Docket No. 50-255 ←

Change No. 5
License No. DPR-20

SUPPLEMENT NO. 5

PALISADES PLANT

FIGURE 2.1
AVERAGE FUEL TEMPERATURE VS. KW/FT
ASSUMING INSTANTANEOUS DENSIFICATION

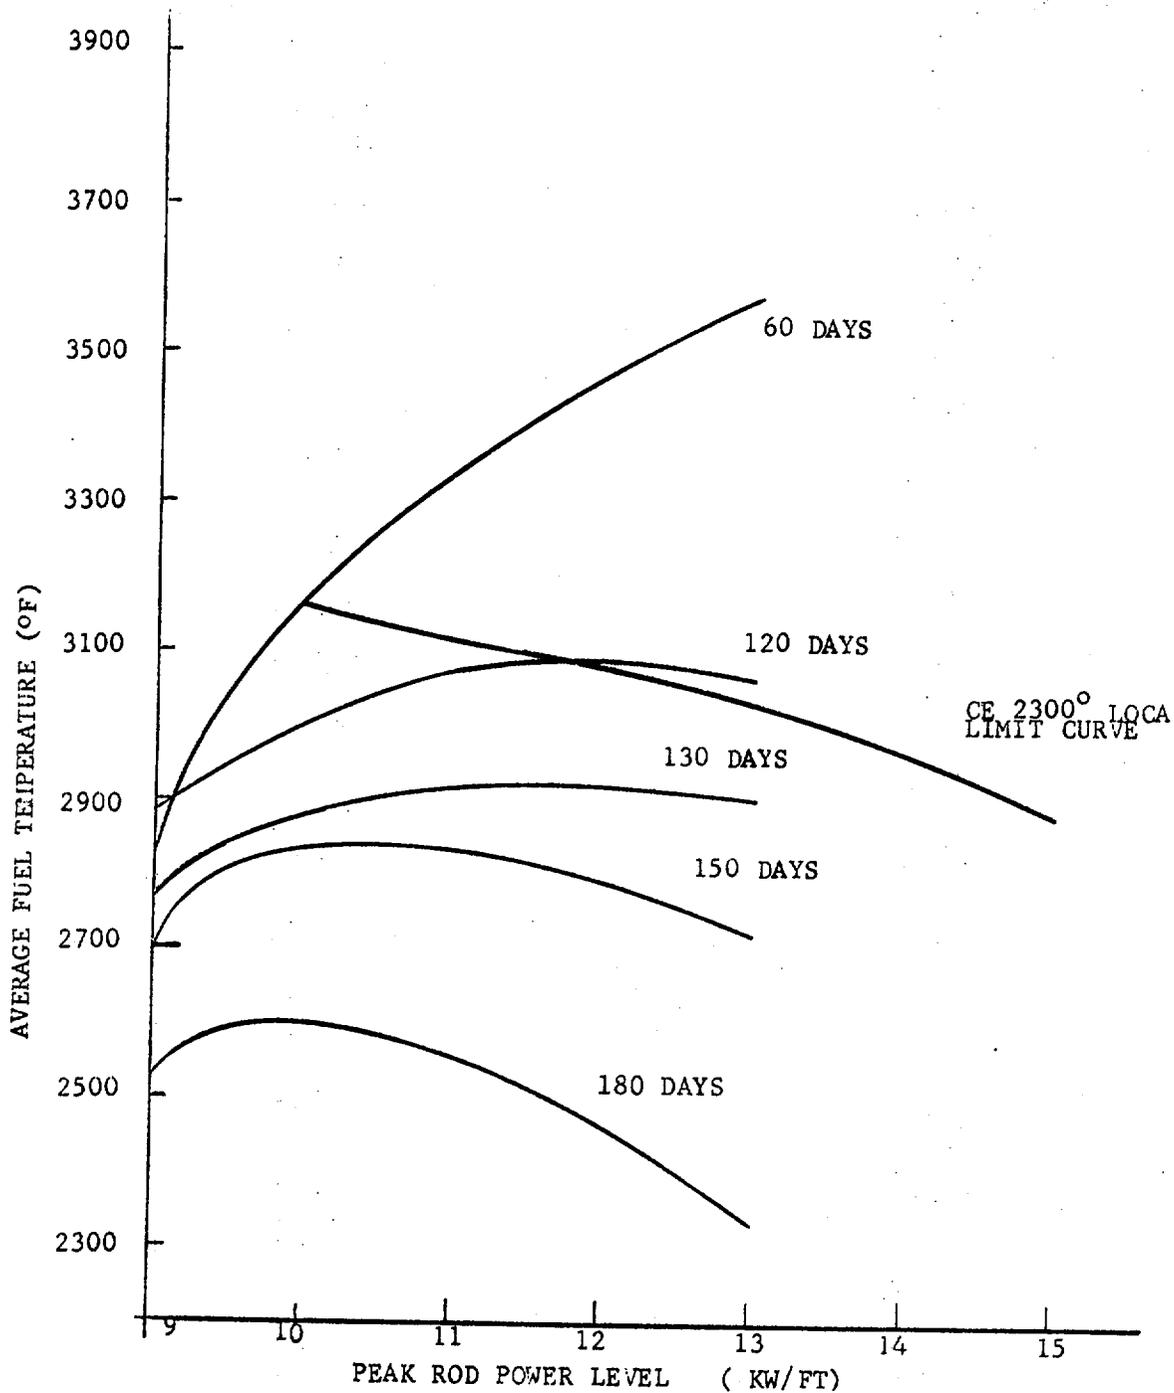
To evaluate the level of operation for Palisades, CE provided a plot of allowable peak linear heat rate as a function of average fuel temperature. The limit line is based on a peak cladding temperature of $2300^{\circ}F$ for the LOCA calculation. As was discussed earlier, fuel pellet average temperature as a function of exposure was calculated for several linear heat rates. The values plotted on Figure 2.1 of average temperature for the instantaneously densified fuel were reduced by $100^{\circ}F$ prior to plotting to account for elastic deformation of the cladding.

The CE LOCA limit plot is overlaid on Figure 2.1. The intersection of the limit line with temperature curve for the appropriate temperature and linear heat rate are plotted on Figure 2.2. This curve will form the basis for Technical Specifications limiting operation of the Palisades plant.

FIGURE 2.2
ALLOWABLE LINEAR HEAT RATES
IN PALISADES REACTOR

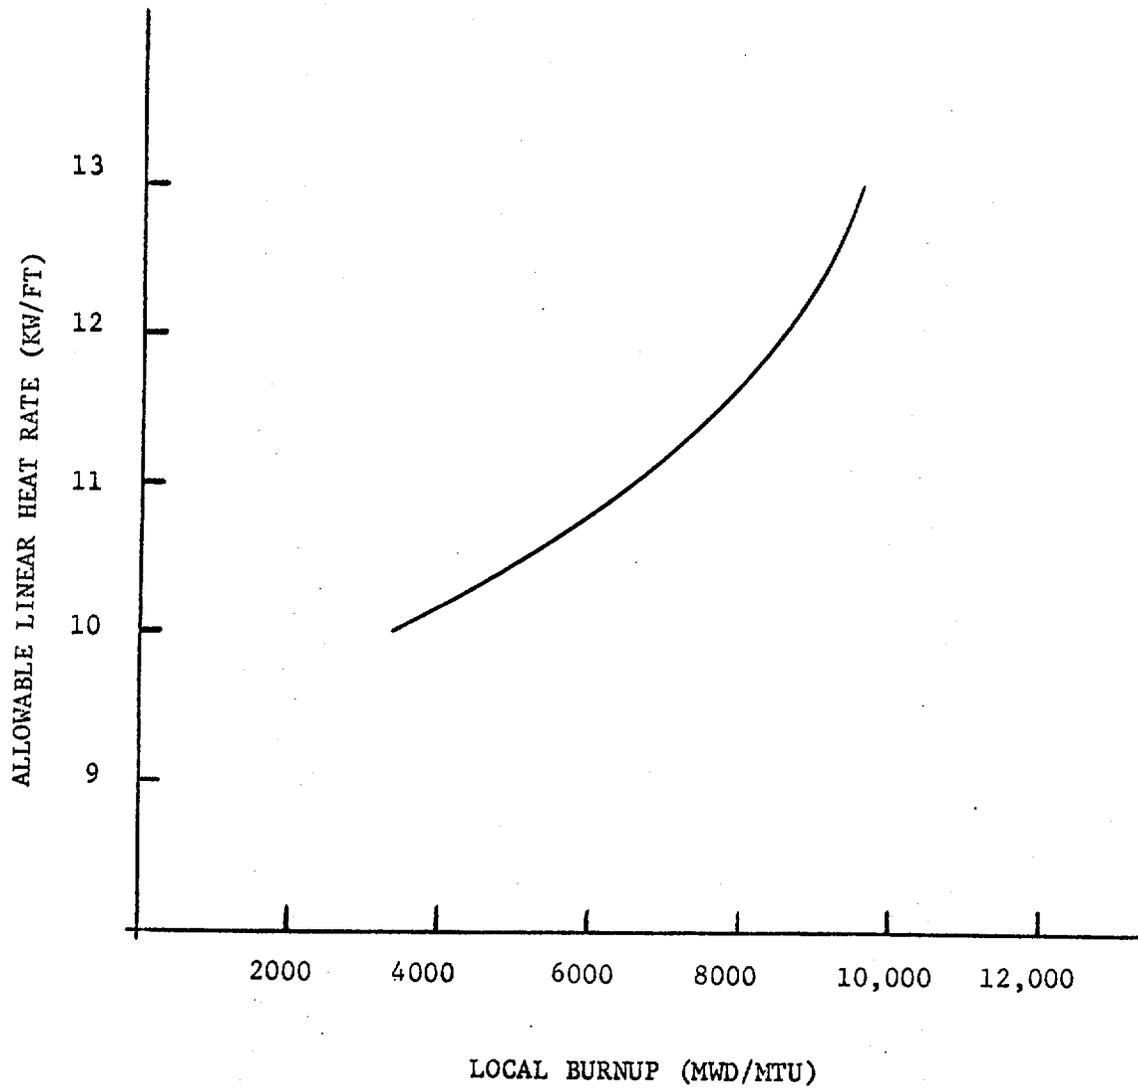
Consideration of the LOCA analysis by the applicant resulted in a limitation on the peak linear heat generation rate as a function of burnup based on instantaneous densification as shown on Figure 2.2. For the rates shown, the calculated peak cladding temperature is limited to 2300°F.

FIGURE B-1
ALLOWABLE LINEAR HEAT RATES
IN PALISADES REACTOR

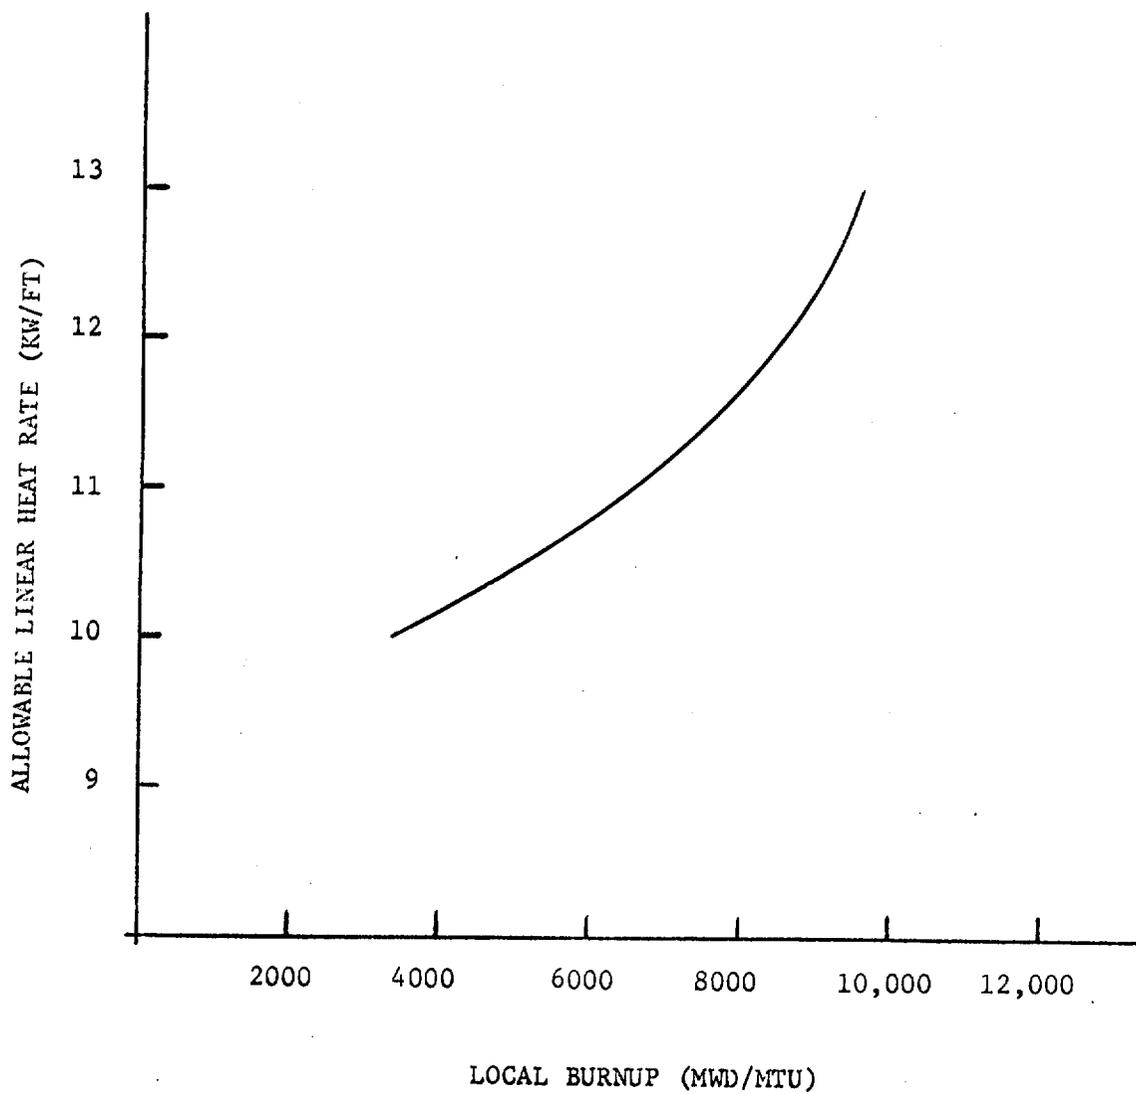
3. For a core average burnup of less than 6000 MWD/ MTU:
 - a. The peak linear power with appropriate consideration of normal flux peaking, flux peaking augmentation factors, measurement-calculational uncertainty (10%), engineering factor (3%), increase in linear heat rate due to axial fuel densification (1.75%) and power measurement uncertainty (2%), shall not exceed the kW/ft limit shown in Figure B-1.

FIGURE B-2

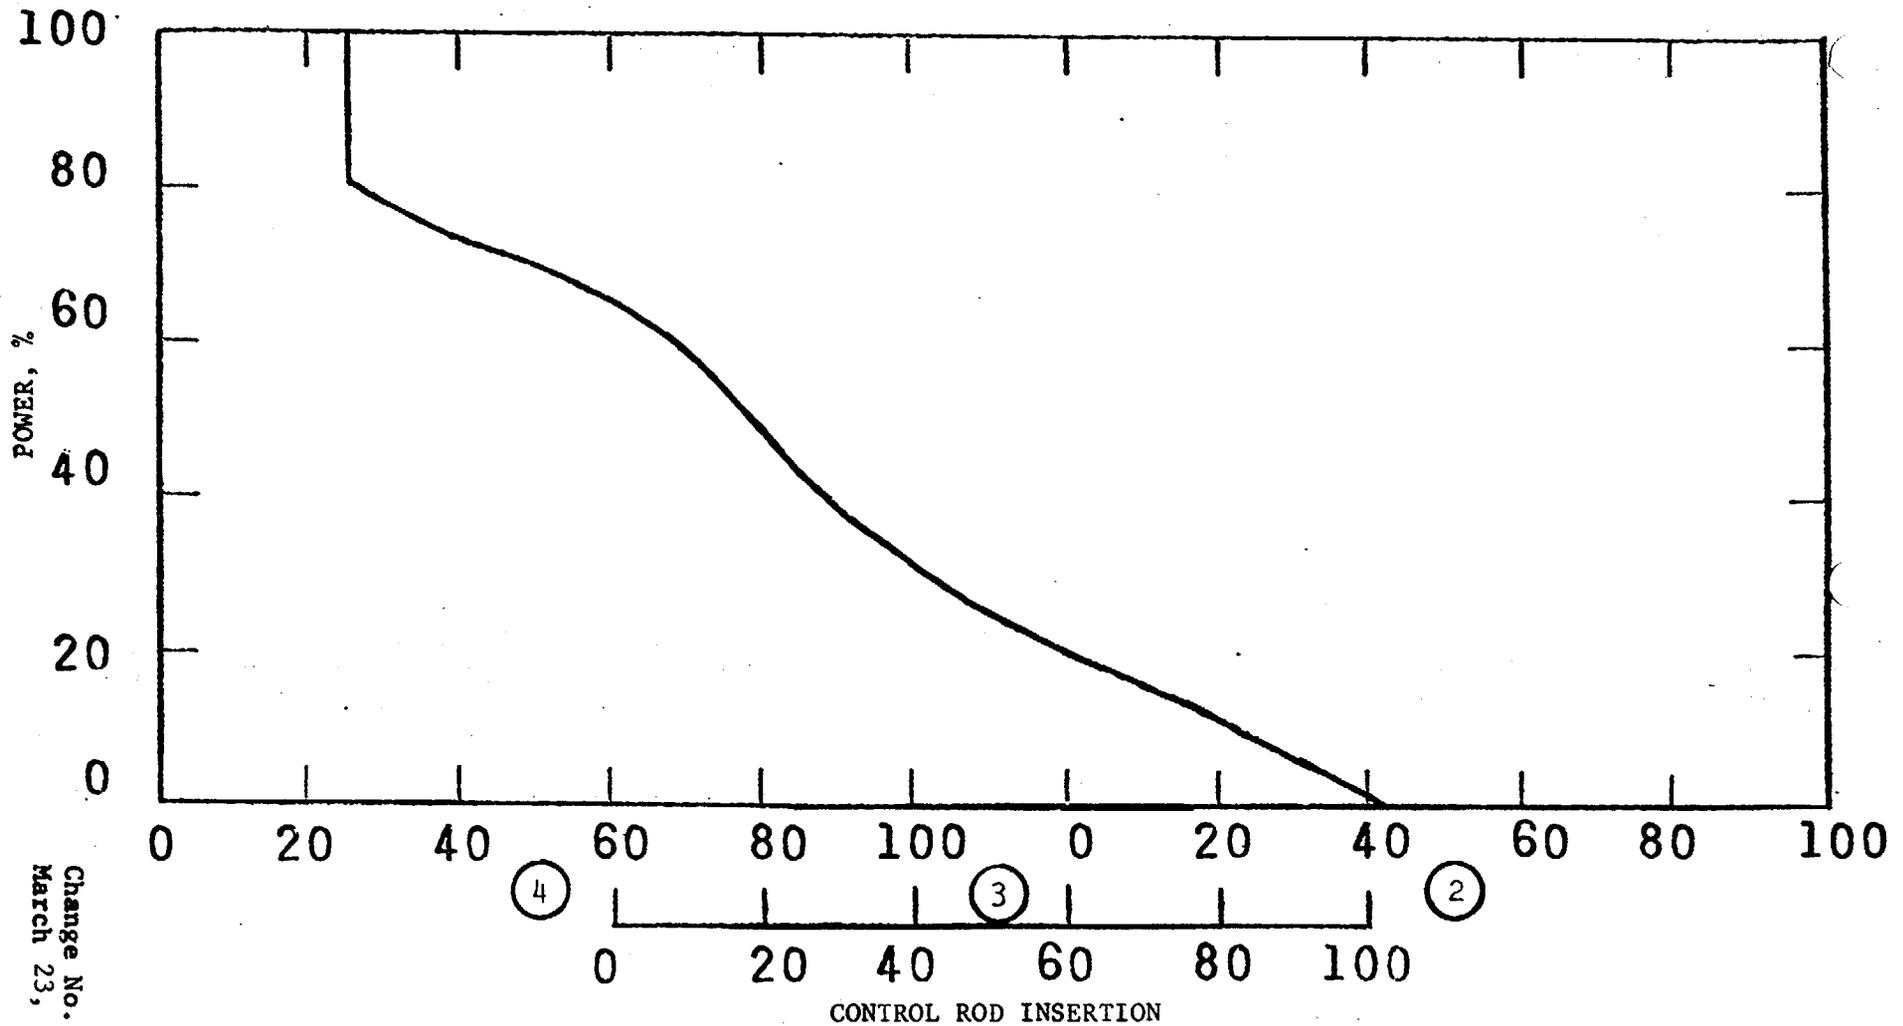
7. Control rod insertion limits will be in accordance with Figure B-2, except for physics tests and CRDM exercises.
 8. The reactor coolant temperature at the inlet to the reactor vessel shall be no greater than 525 °F during steady state operation above 80% of full power.
